R.F.I.

Project #:	664-14-105	RFI #:	
Project Name:	Occupational Therapy/Physical Therapy Renovation	Date Requested:	3/27/14
Solicitation No.:	VA262-14-B-0366	Reference:	
Drawing:	AE-102, AE-401	Specification Section:

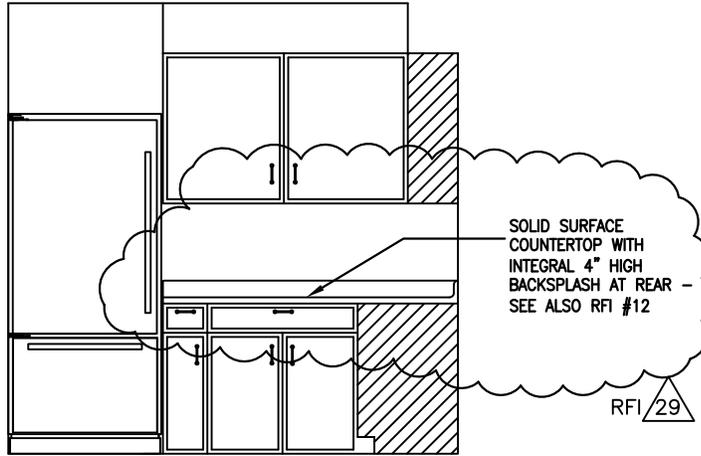
The finish schedule on Sheet AE-401 calls for Office room 1447 to receive vinyl sheet flooring (VSF). However, Room 1447 doesn't show on the remodel floor plan Sheet AE-102. Is this room part of the contract scope of work?

Delete reference to and requirements for Room 1447 on Room Finish Schedule on Drawing Sheet AE-401.
